MIL-P-48322B (AR)
AMENDMENT 7
6 February 1987
SUPERSEDING
AMENDMENT 6
8 February 1985

MILITARY SPECIFICATION

PROJECTILE, 8 INCH, HE, RA, M650
AFT WARHEAD SECTION AND STRIPPABLE COATING ASSEMBLY

FIGURE 2.
Depth of Knurl.

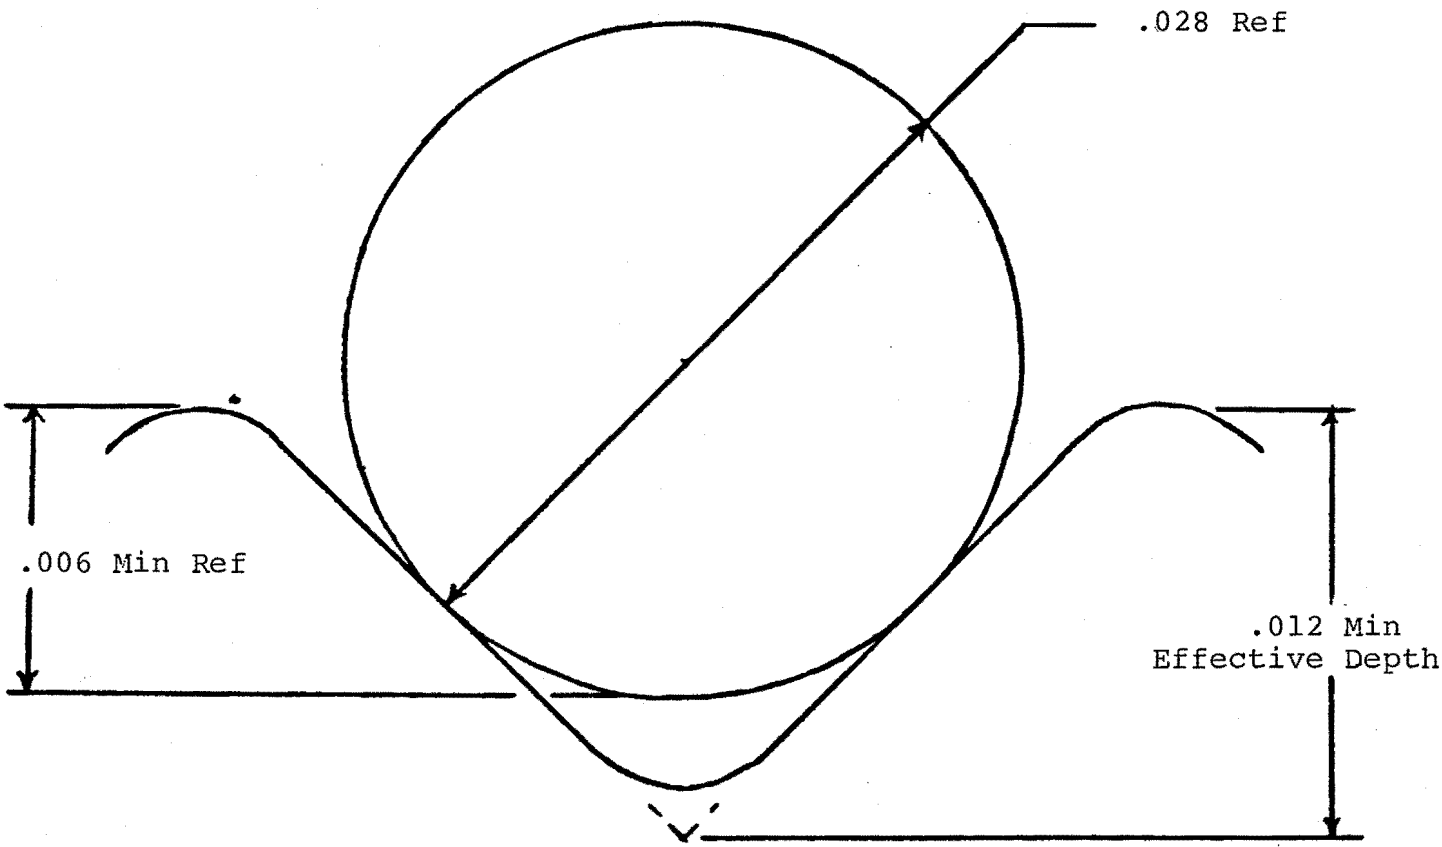
"3.15 Knurl. The minimum effective depth of the radial grooves in the knurl shall be .012 inches between the first and sixth peaks (See Figure 2)."

Add "Figure 2" as follows:

"4.4.3.11 Depth of knurl.

4.4.3.11.1 Initial sampling. The first pieces from each tool, forming the radial groove, shall be inspected for depth until one part has been accepted.

4.4.3.11.2 Subsequent sampling. If the life of the tool forming the radial grooves is 50 parts or less, the last part formed by each tool shall be inspected. If tool life is greater than 50 parts, an additional inspection of one part from each 50 shall be performed. If the knurl depth is less than .012 inches, production represented by that sample shall be rejected, production shall be stopped and corrective action taken. Sampling for any tool producing a rejected part shall revert to 4.4.3.11.1 if that tool is returned to production."

"4.5.14 Depth of knurl. The depth of the radial groove in the knurl shall be checked using a dial indicating depth gage or approved equivalent."

FIGURE 3.
Approximate Location of Tension and Charpy Base Specimens
(T- Tensile, C - Charpy)

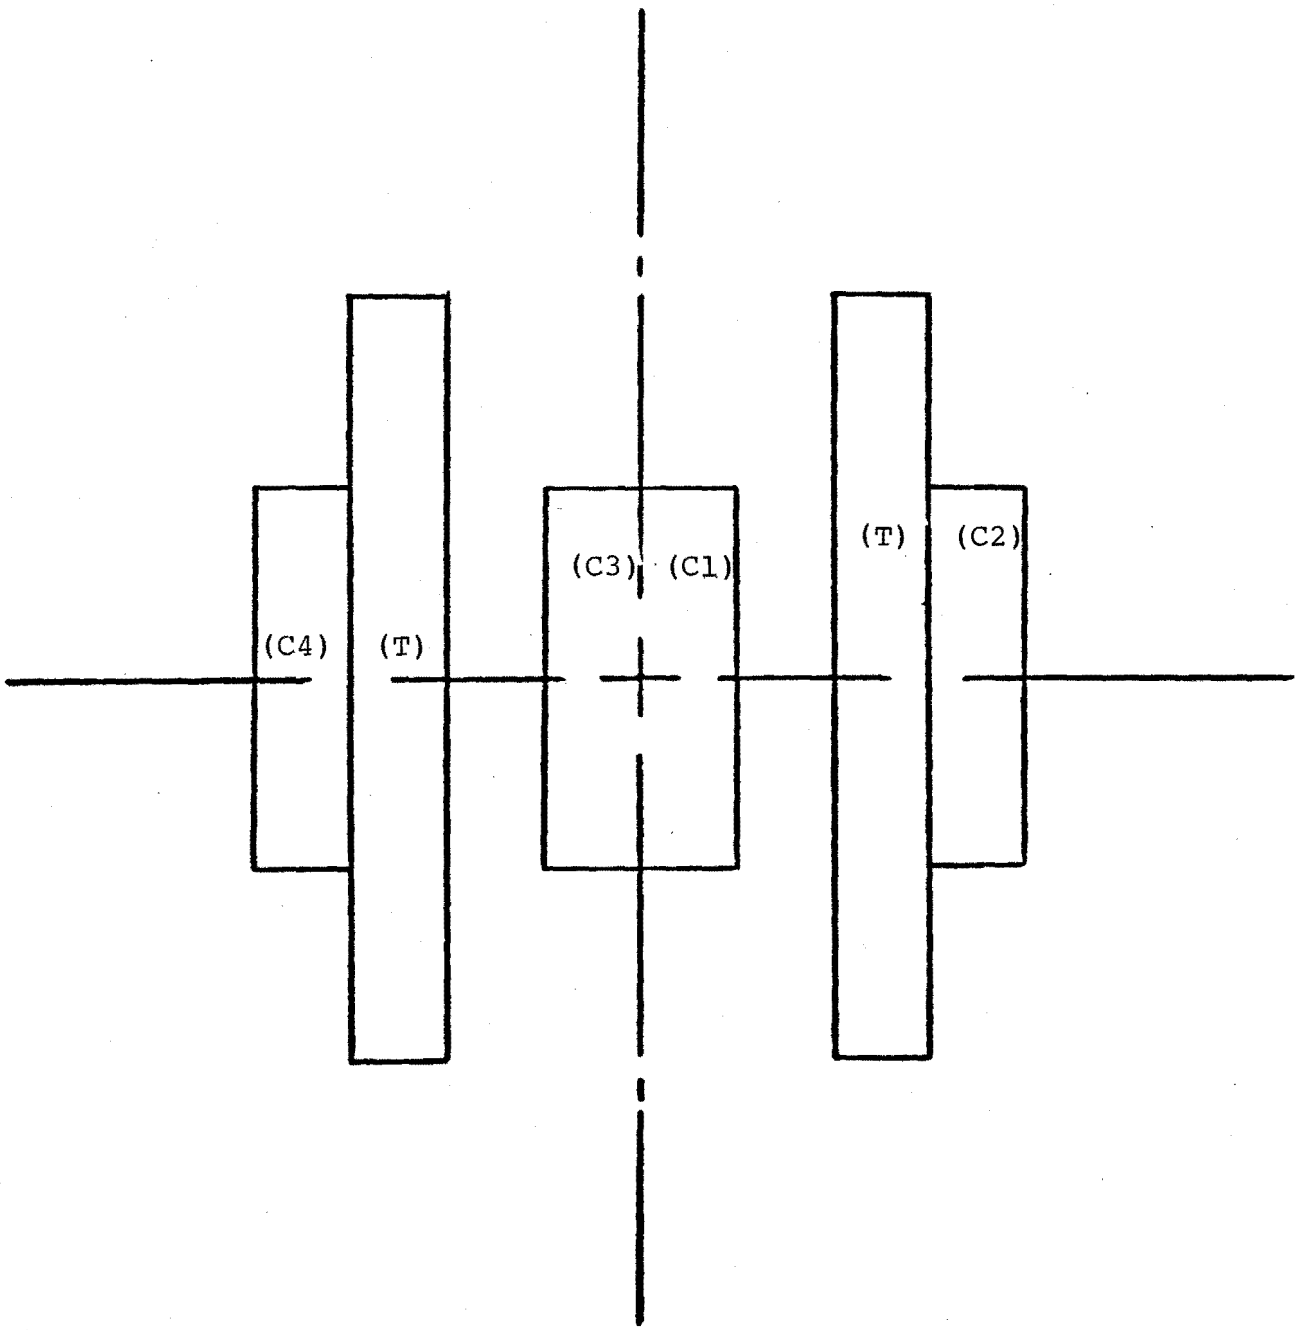
Add "Figure 3" as follows:

"4.5.3 Slow bend precrack charpy. The two specimens shall be taken from locations C1 and C2 on Figure 3. The test shall be conducted at a specimen temperature of -65 degree fahrenheit (^{O}F). The test shall be conducted in accordance with the procedure defined in the Appendix of this specification with the notches machined across the rear face of the specimen. Locations C3 and C4 on Figure 3 shall be used for replacement specimens for locations C1 and C2 respectively."
